寄件者: Ping Yeung < >
寄件日期: 2025年10月30日星期四 10:06
收件者: Brian Ching Hong CHAN/PLAND
主旨: 打鼓嶺坪洋村DD79 LOT193 RP (part), 197 (part), 198 (part)補充申請臨時停車場資料
附件: TKL818_layout.pdf; TKL818_Swept Path.pdf
類別: Internet Email

寄件者: Ping Yeung < >
寄件日期: 2025年10月31日星期五 7:00
收件者: Brian Ching Hong CHAN/PLAND
主旨: Re: 打鼓嶺坪洋村DD79 LOT193 RP (part), 197 (part), 198 (part)補充申請臨時停車場資料
附件: TKL818_Swept Path2.pdf
類別: Internet Email

4.停車場出入口的圖如上：

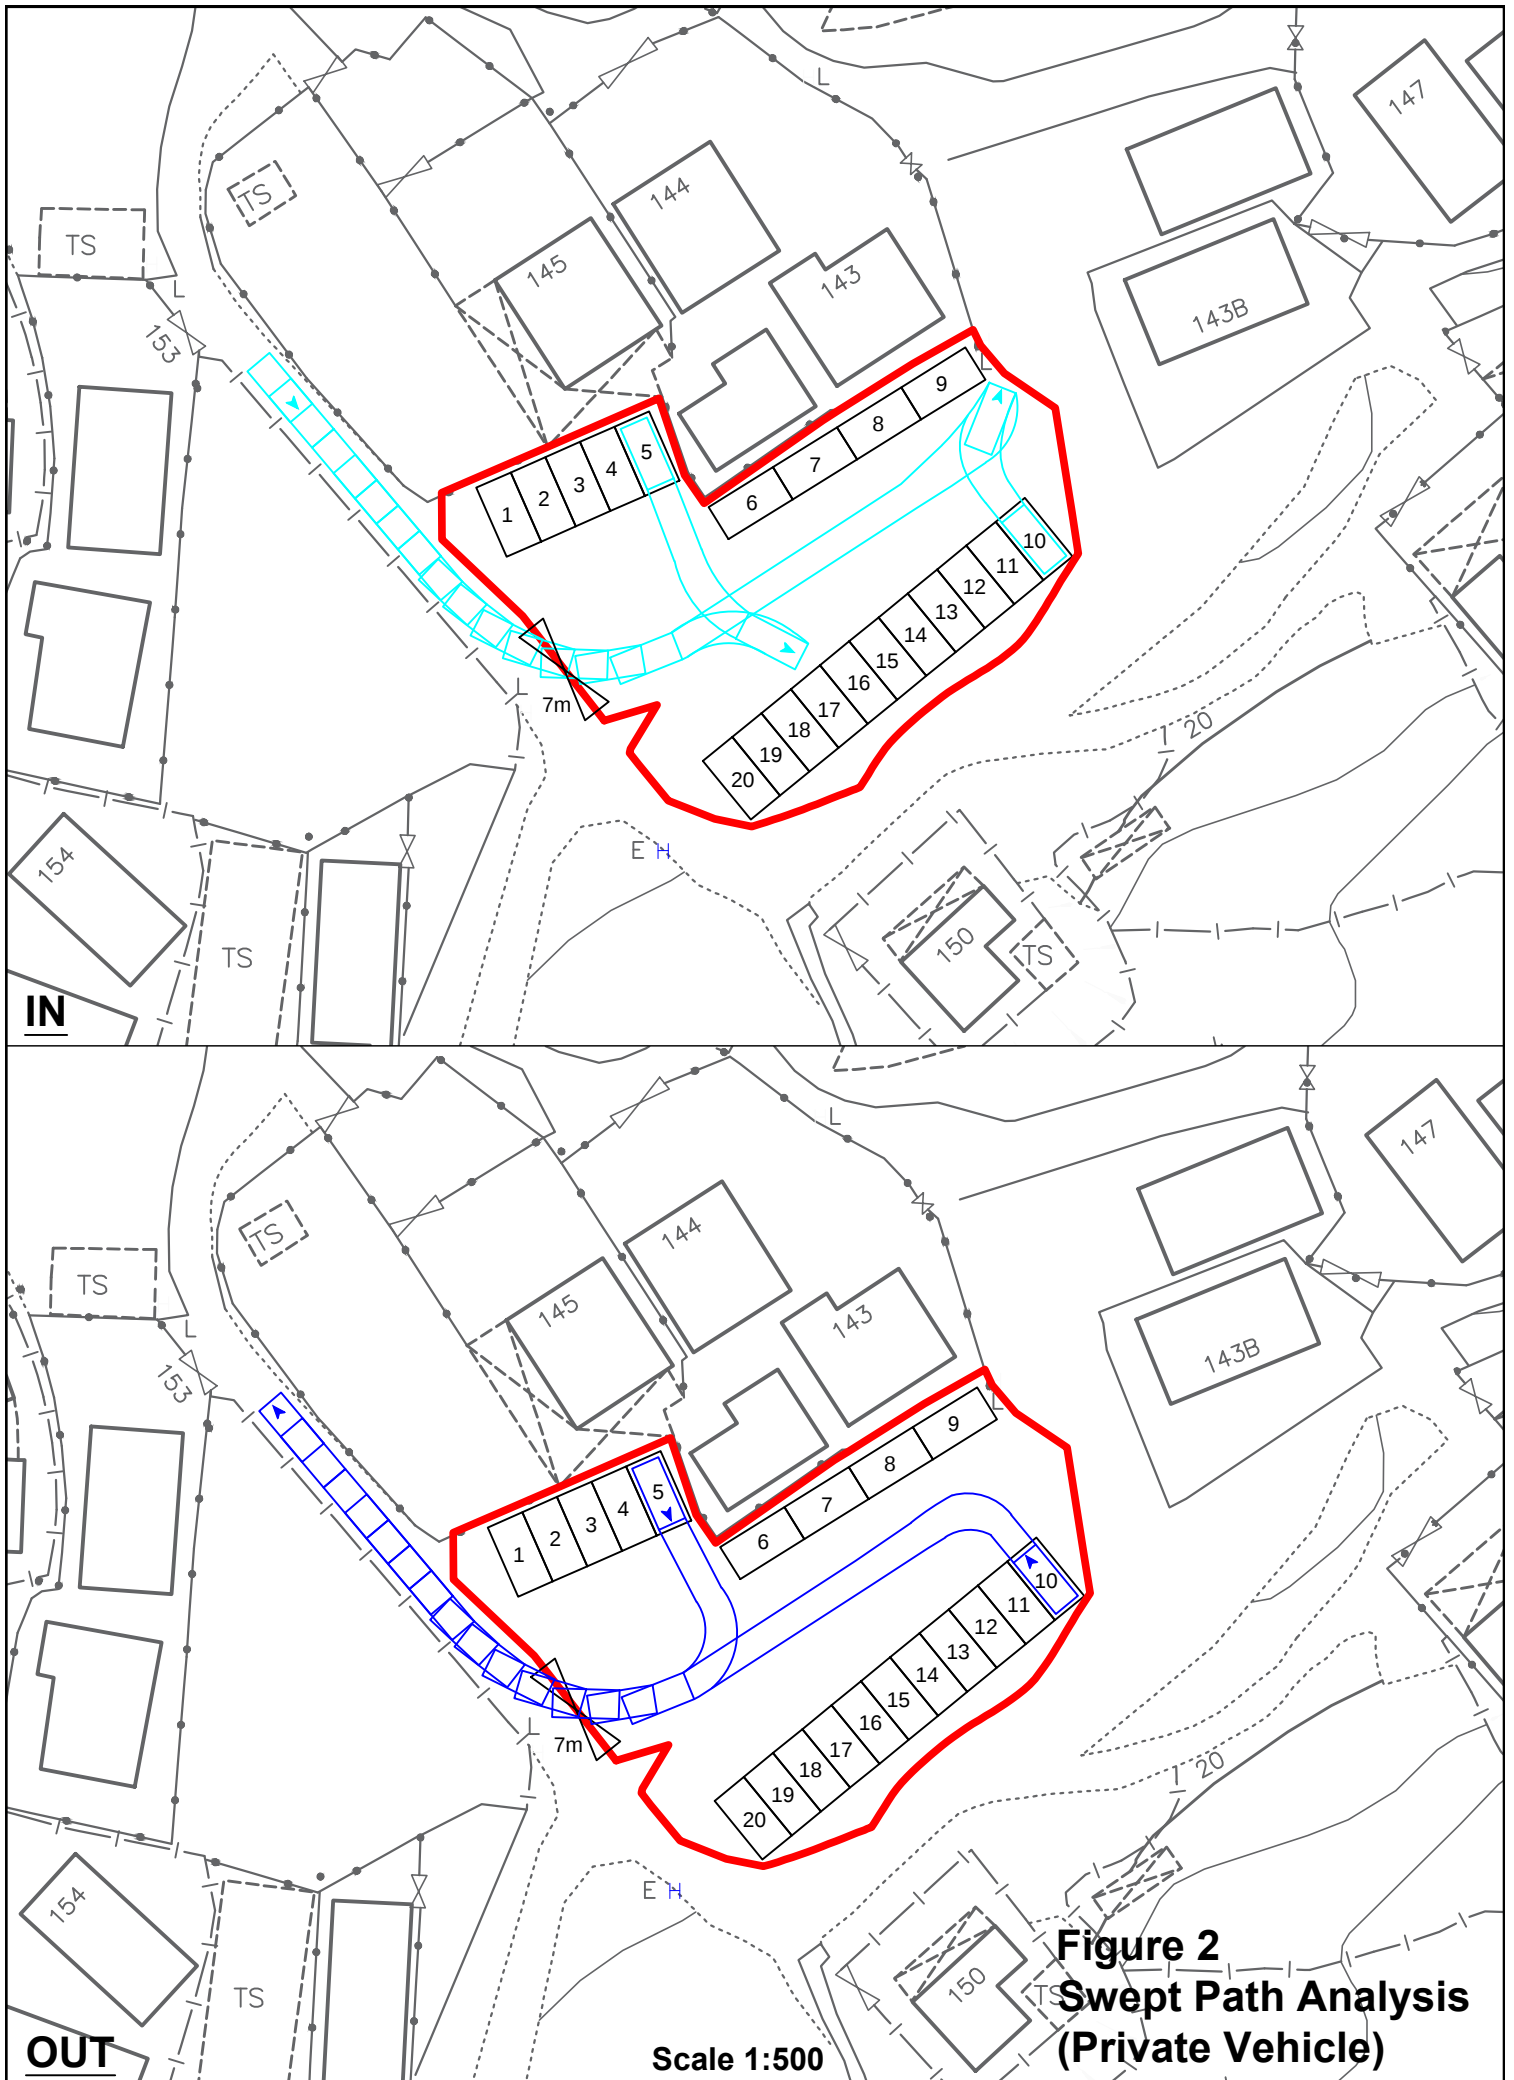
(i) The applicant shall demonstrate the satisfactory maneuvering of the vehicles entering and exiting the subject site, maneuvering within the subject site and into / out of the parking spaces preferably using the swept path analysis; and

(ii) The proposed vehicular access between Ping Che Road and the application site is not managed by TD. The applicant should seek comments from the responsible party.

1.停車場不設電動車充電設施，原因

i)有些電動車車主在其屋外設有充電設施，ii)村內有人在申請充電站

2.根據《道路交通條例》所有車輛必須持有有效的行車證，方可停泊此停車場

3.停車場只供本村村民停泊車輛
